ADDENDUM NO. 1

DEERFIELD
Federal Aid Project No. BFL(BR-OFF)-0032(052)X
Bridge Replacement, D-06-001,
Upper Road Over Deerfield River

Transmitting revisions to the Contract Documents as follows:

Revised Plan Sheets 47, 49, 50, 51, 52, 61 & 63 of 92.

FOUNDATION LAYOUT PLAN AND DETAILS

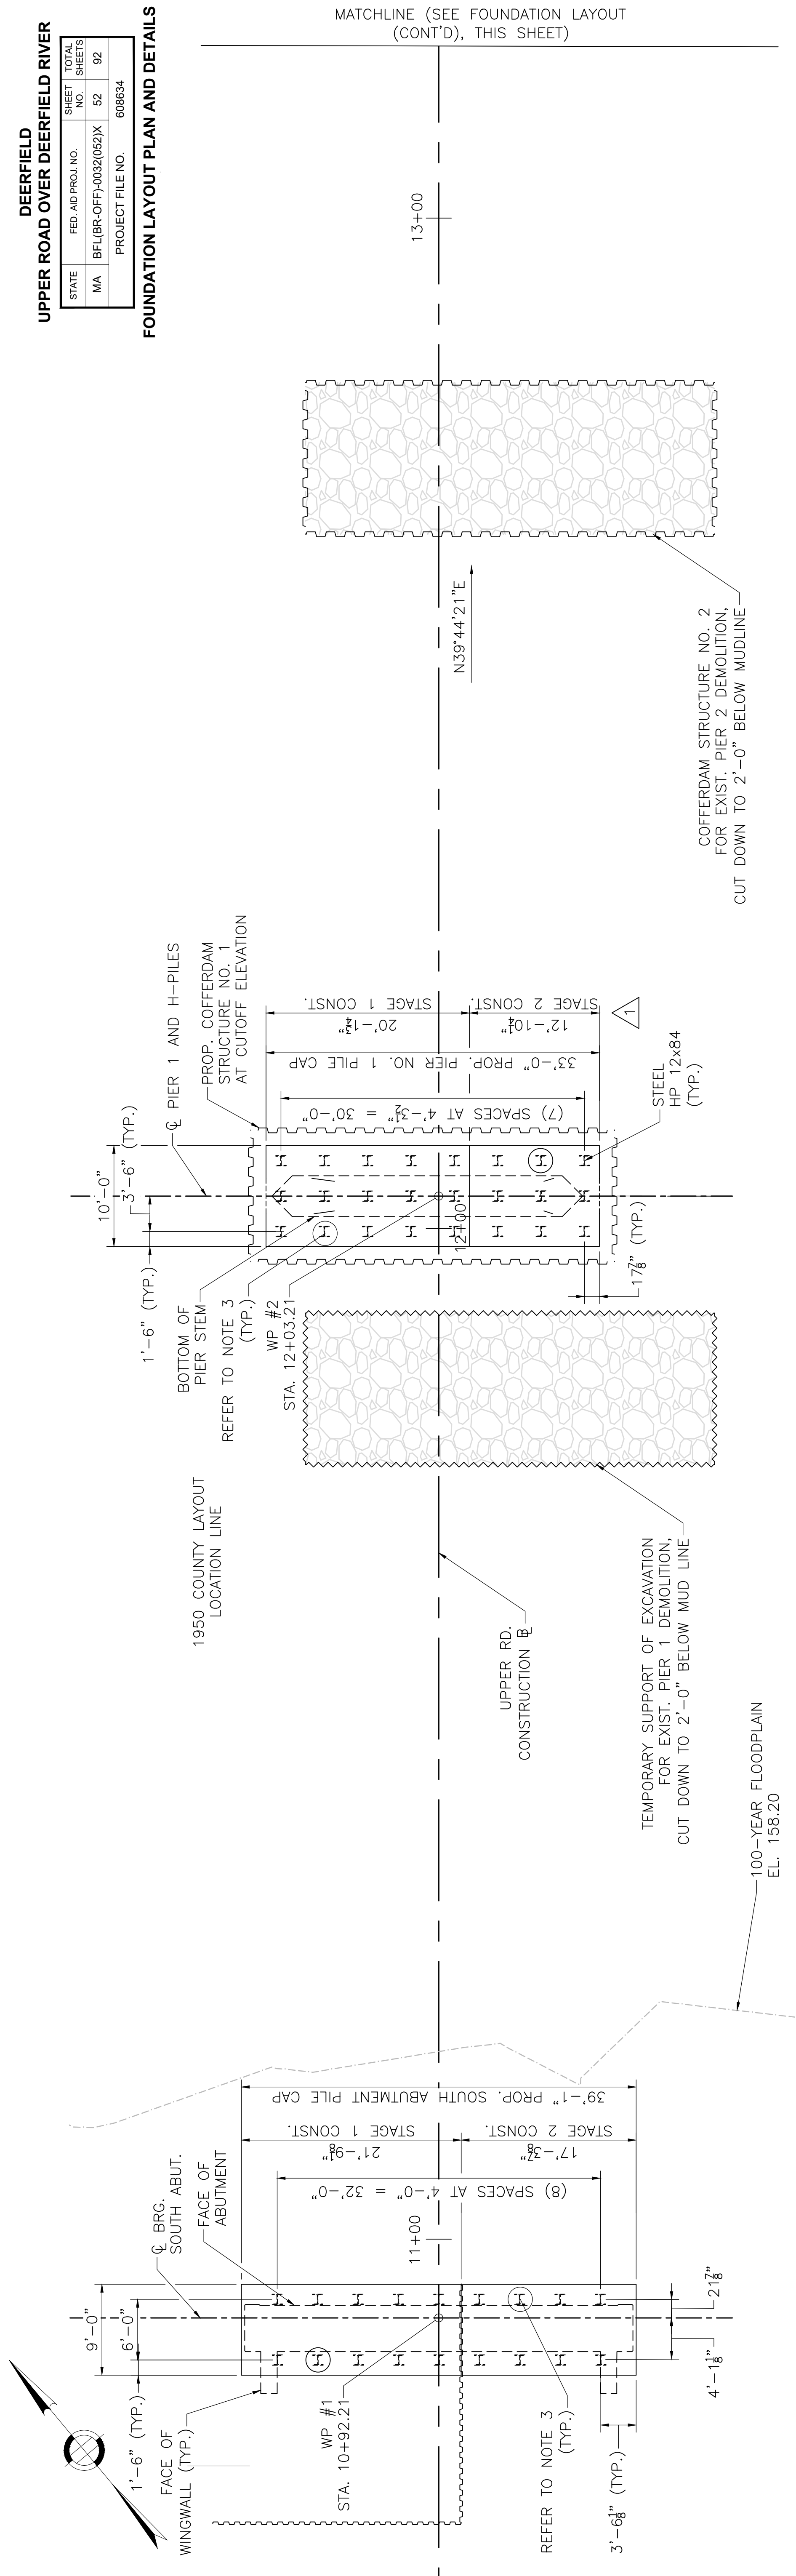
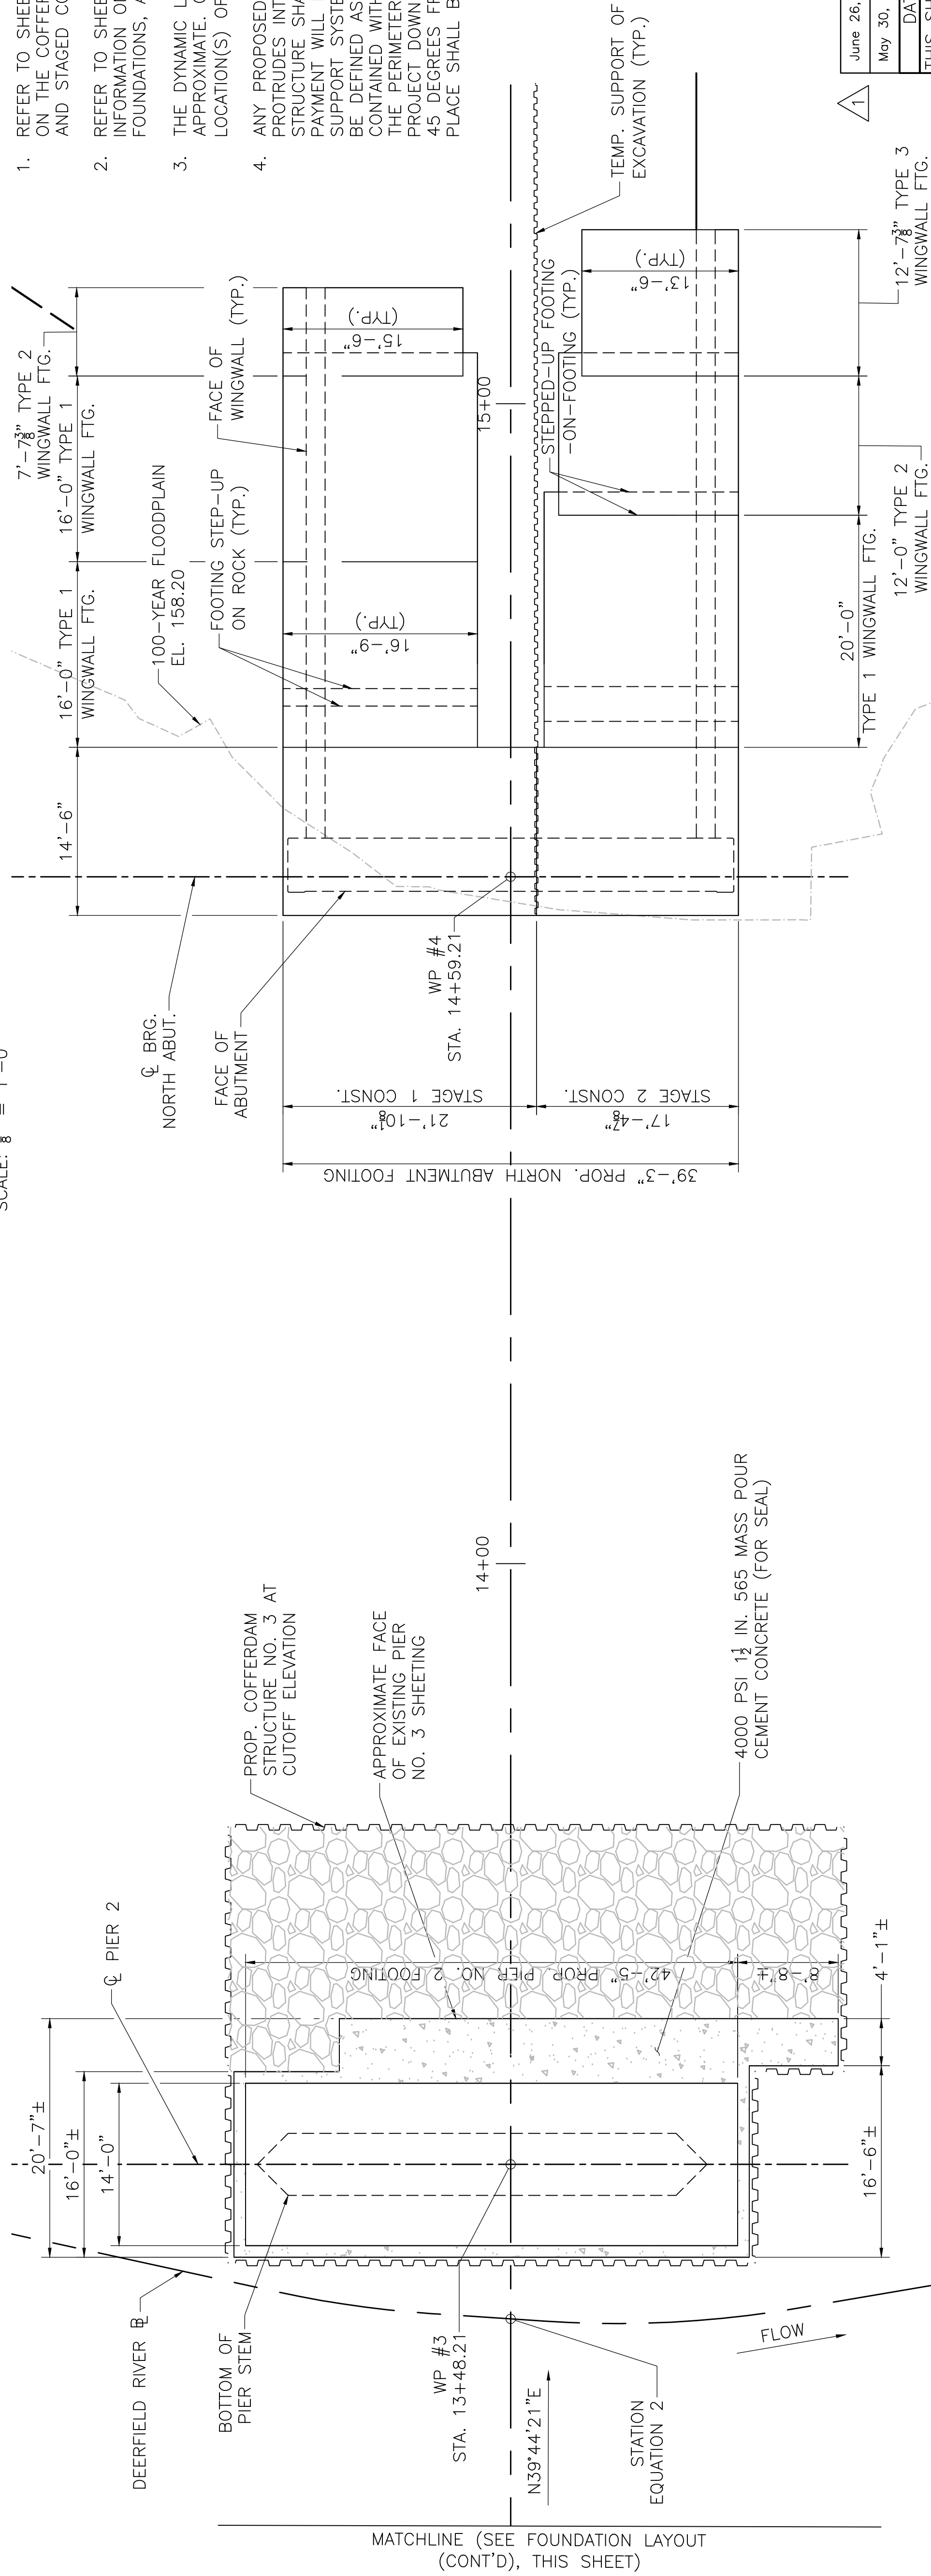
Can Pier 1 be installed and built with construction joints in the footing and stem for the phased construction approach, like what is shown for construction joints in the south abutment?

See revised Plan Sheets 47 of 92 (11 of 41), 49 of 92 (13 of 41), 50 of 92 (14 of 41), 52 of 92 (16 of 41), 61 of 92 (25 of 41), and 63 of 92 (27 of 41) issued via this addendum.

June 26, 2026	STAGE 1 LIMIT ALTERED
May 30, 2026	ISSUED FOR CONSTRUCTION
	DESCRIPTION
THIS SHEET IS APPROVED FOR CONSTRUCTION BY MASSDOT	
AUTHORIZED SIGNATORY: <u>STATE BRIDGE ENGINEER</u>	
USE ONLY PRINTS OF LATEST DATE
